COMMENTS FROM REFEREE 1:

The manuscript hess-2020-268 titled “Landscape scale remediation reduces concentrations of suspended sediment and associated nutrients in alluvial gullies of a Great Barrier Reef catchment: evidence from a novel intensive monitoring approach” has been reviewed. The manuscript is really interesting and fits in the broad scope of the journal. The authors present a detailed comparison analysis of two gullied areas in Australia: One remediated area and one control area. I consider that moderate/major revisions should be carried out before a final decision. Some important questions should be answered and small issues should be improved.

Intensive landscape-scale remediation improves water quality of an alluvial gully located in a Great Barrier Reef catchment

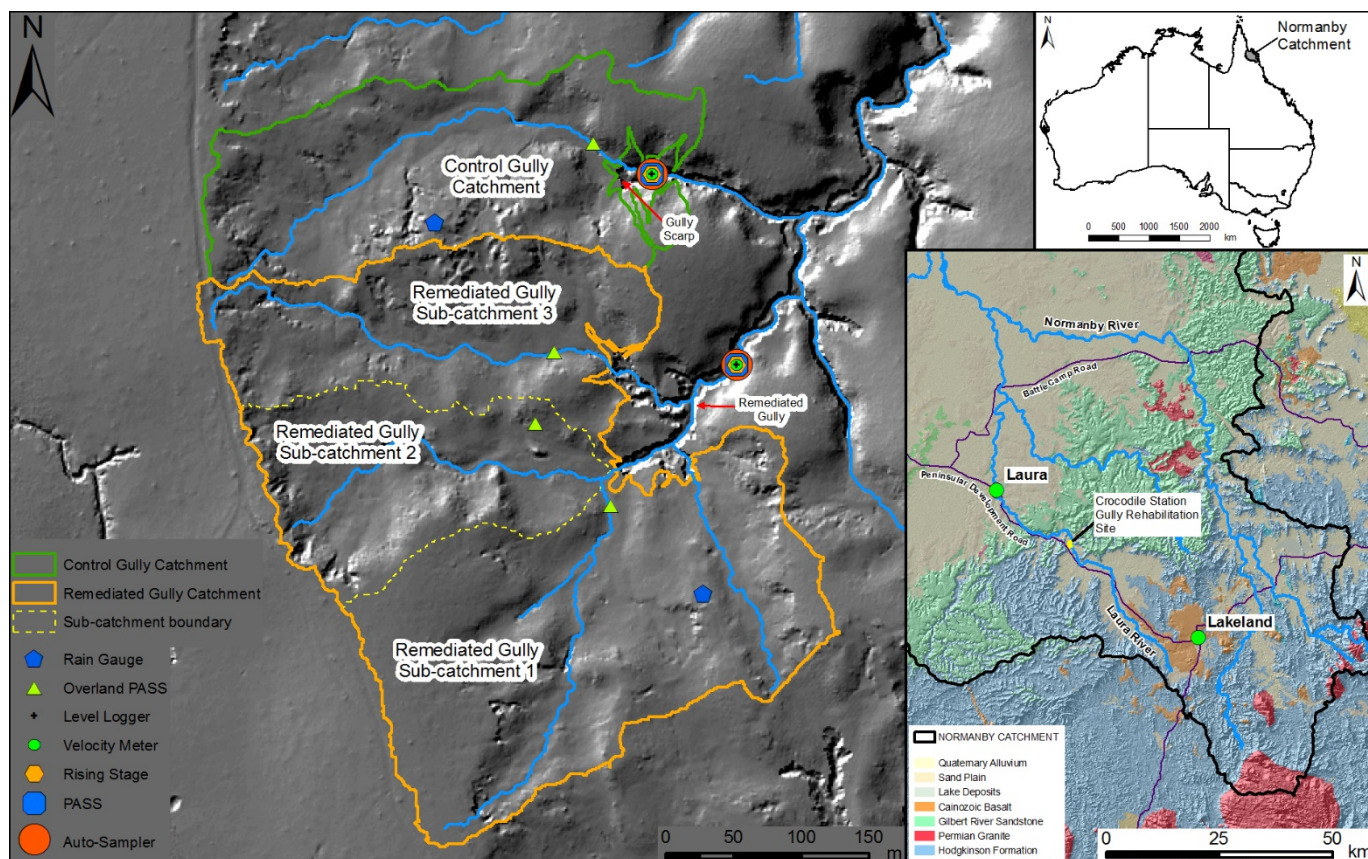
Specific Comment 2. “Placement of devices in the gully catchments: catchment 3 PASS is not on a drainage line but catchment 1 and 2 are (assuming blue lines in Figure 1 are drainage lines found using some routing method?). This seems to have an impact on measured sediment concentrations (for catchment 3 the upper SSC is 3556 while catchment 1 and 2 are 563 and 1517, respectively). Given the focus of the paper is on measurement methods I think a little more discussion about the placement of sensors would be good. I think some more discussion of this is important because it seems to have important implications for your conclusions. Taking the lower end estimate of TWA SSC from the control gully gives 4453 and the upper estimate from the hillslope in catchment 3 is 3556 which is ~80% of what is seen in the control gully. Without a larger sample it’s hard to know whether this is representative or not but for me it suggests the possibility that hillslope erosion, in this environment, is a considerable source of fine sediment (potentially almost equal to gully erosion?). Given that, I think it warrants a little more discussion around possible ways to address the influence of sensor locations with respect to process interpretation.”

Specific Comment 5. “Line 95 I’m confused. You wrote in the text that you used two gullies in the study, whereas in Figure 1 you marked three remediated gully catchments and one control gully catchment. Were these three gully catchments treated as one? Can you mark them together for instance with the same colour line or somehow marked them as one site?”

RESPONSE: **Acknowledge/clarify.** The Referee makes a good point regarding the need for more detailed description of overland flow sampling methodology. Please note that the blue draining lines show in Figure 1 are only indicative of the actual overland flow characteristics observed at the site. Other factors (e.g., vegetation, natural debris, and termite mounds) influence water flows in ways that are not perceived by airborne Lidar-derived flow lines. The overland flow sampling locations were chosen based on observing locations that had consistent flows and were as close as possible to the transition of catchment to gully. The sampler located at catchment three was placed in a different location to the drainage line indicated in Figure 1 because of the presence of termite mounds and vegetation. The authors thank the Referee for making this observation and will provide commentary in the caption of Figure 1 to provide context for the blue flow drainage lines. The authors will also revise the text in the methods (Lines 181-185) to include more detail and photographs of overland flow at the sampling locations (these will be provided as supplementary information).

Note text has been added to the caption of Figure 1 regarding the placement of PASS samplers in the gully catchments.

Line 138-140: “N.B. The overland PASS sampler in sub-catchment 3 of the remediated gully was deployed several metres away from the flow line inferred by surface geology due to the redirection of flow associated with vegetation and termite mounds.”

RESPONSE: *Clarify/Accept.* Please refer to the revised Figure 1.

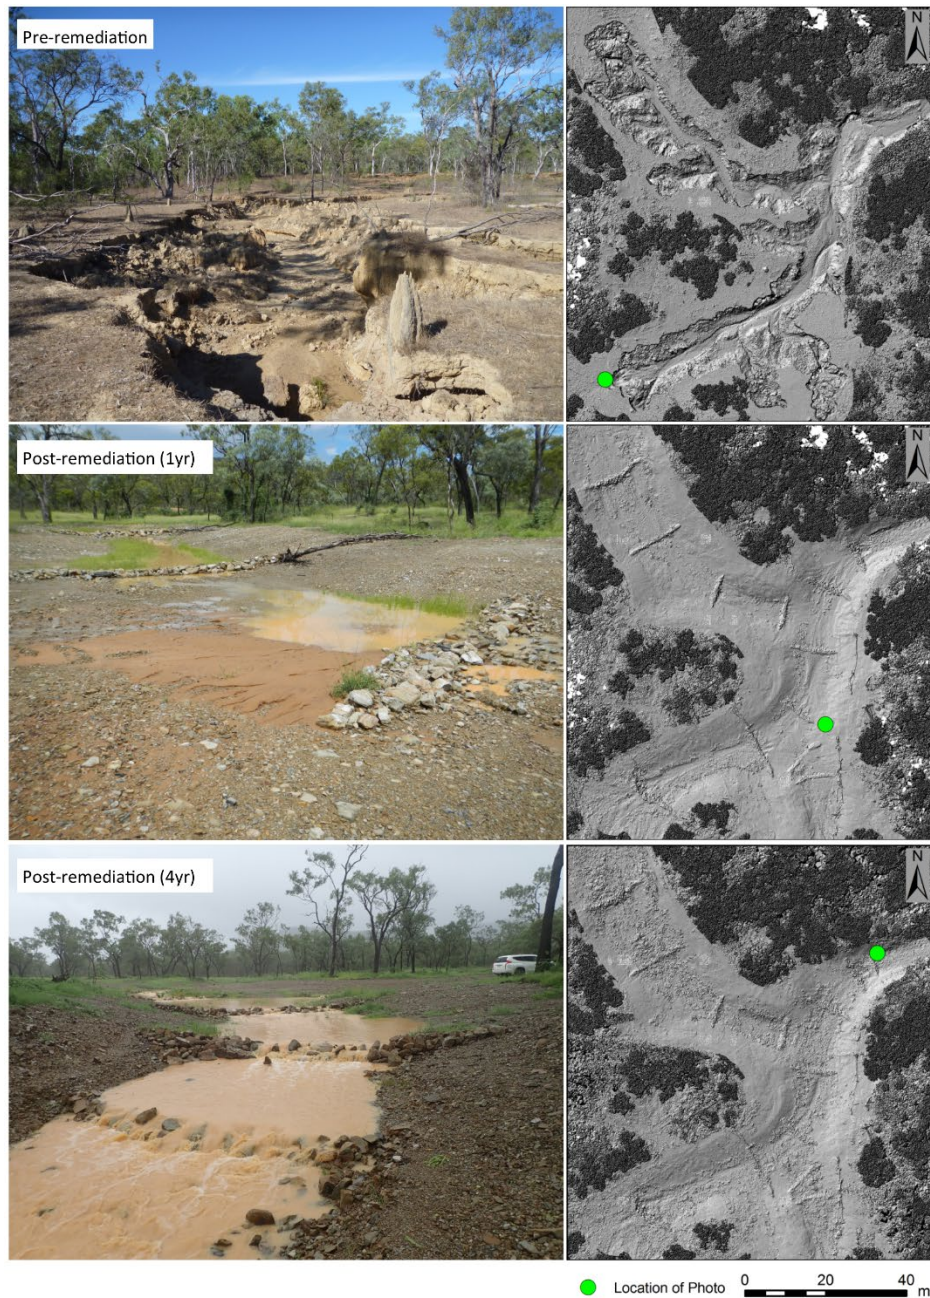
Specific comment 4 . “If possible, I think a before remediation and after remediation DEM image (or DEM of difference maybe) would be a useful addition.”

Specific Comment 6. “Lines 120-129 I suggest to include some photos from the study area. I know that you present several photos in the supplement, but I think that some of them should be in the manuscript, e.g., control gully, remediated gully before and after remediation.”

Before and after photos: Please refer to Figure 2

RESPONSE: ***Accept.*** Please refer to Figure 2.

RESPONSE: *Accept.* Please refer to Figure 2.

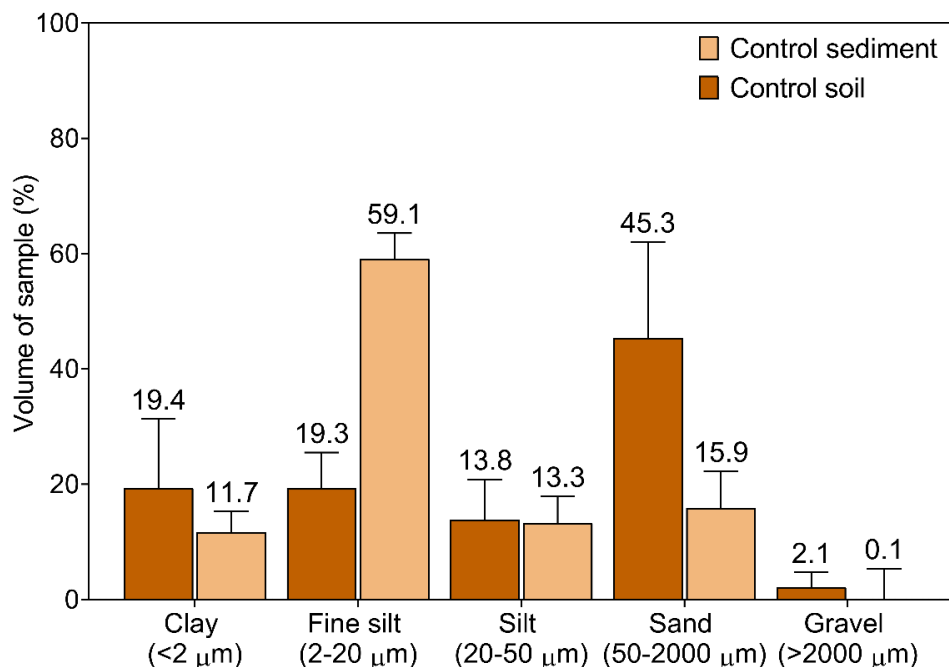
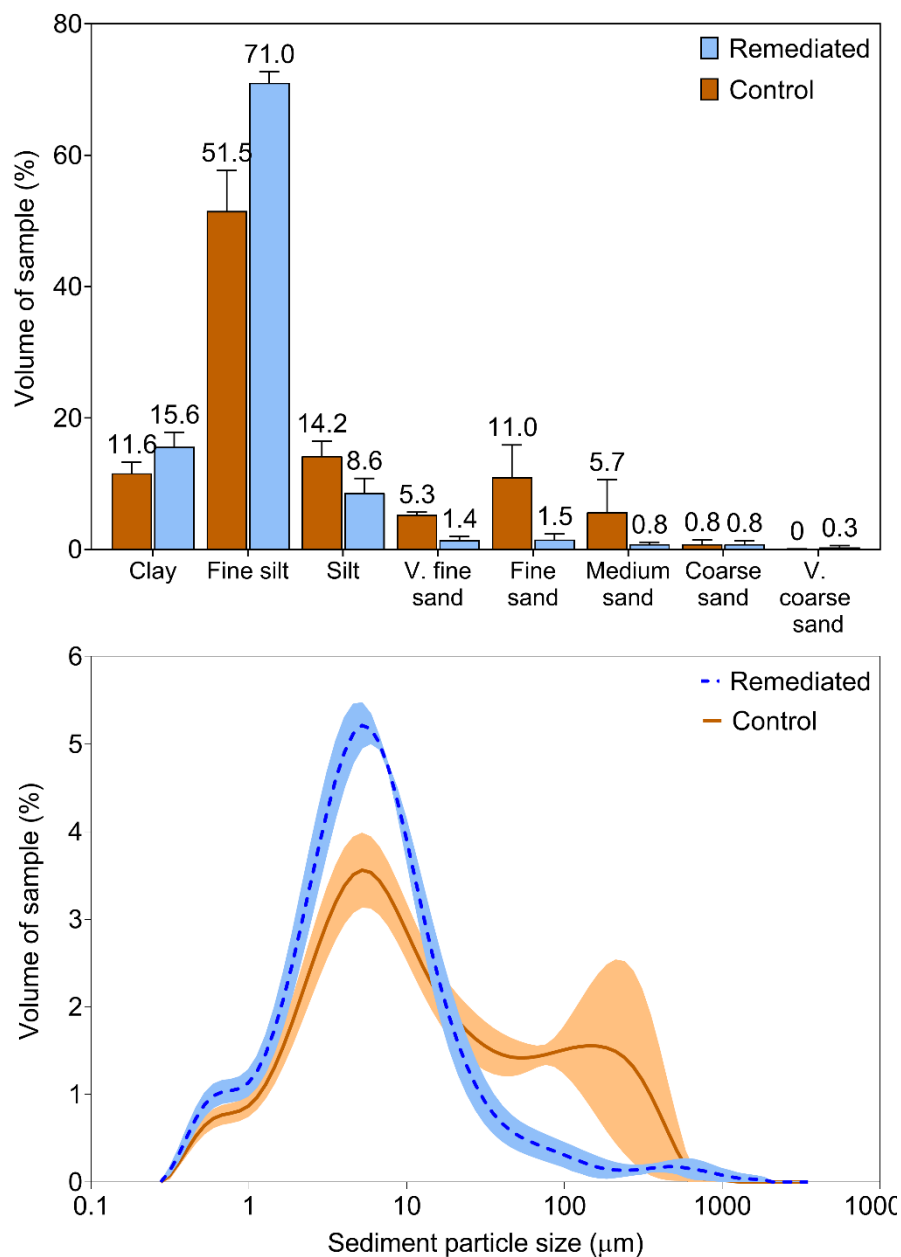
Specific comment 5 . “Figure 7 and 8 seem to suggest that the fine fraction is coming from the catchments more so than the gullies? But there isn’t much discussion about this? Maybe I’m interpreting the results wrong but if this is the case, I think it’s one of the more interesting findings for discussion.”

RESPONSE: *Clarify.* Figure 7 and 8 demonstrate that the distribution of fine sediment (0.1-30 μm) in the suspended sediment samples collected from the catchments and gully outlets are similar. However, further investigation (e.g., geochemical tracing) would be required to differentiate the sources of fine sediment in the gully outlet sample. The authors agree with the referee’s observation that the catchments samples appear to consist of mostly fine sediment as is indicated by in Figures 7 and 8 and Table 3 ($d_{90} < 36 \mu\text{m}$ for all overland flow samples collected). Given this it could be suggested that the catchments contribute some of the fine suspended sediment measured at the gully outlet.

This is discussed in Section 3.2.3 Particle size distribution, Lines 356-368: “The suspended sediment PSD characteristics of control gully catchment PASS samples was notably different to the gully outlet PASS samples (Table 3). This indicates the contribution of slightly coarser suspended sediment from gully erosion ($d_{50} 10.8 \mu\text{m}$) is greater than the suspended sediment contribution of the catchment ($d_{50} 4.29 \mu\text{m}$) in the control gully. In contrast, the PSD characteristics of suspended sediment samples collected from the outlet of the remediated gully (d_{50} of $5.84 \mu\text{m}$) and samples collected from Catchments 2 (d_{50} of $5.52 \mu\text{m}$) and 3 (d_{50} of $5.06 \mu\text{m}$) of the three catchment areas draining into the gully were very similar (Table 3) (Figure 8). This suggests there is a notable contribution of sediment entering both gullies from their respective catchments.”.
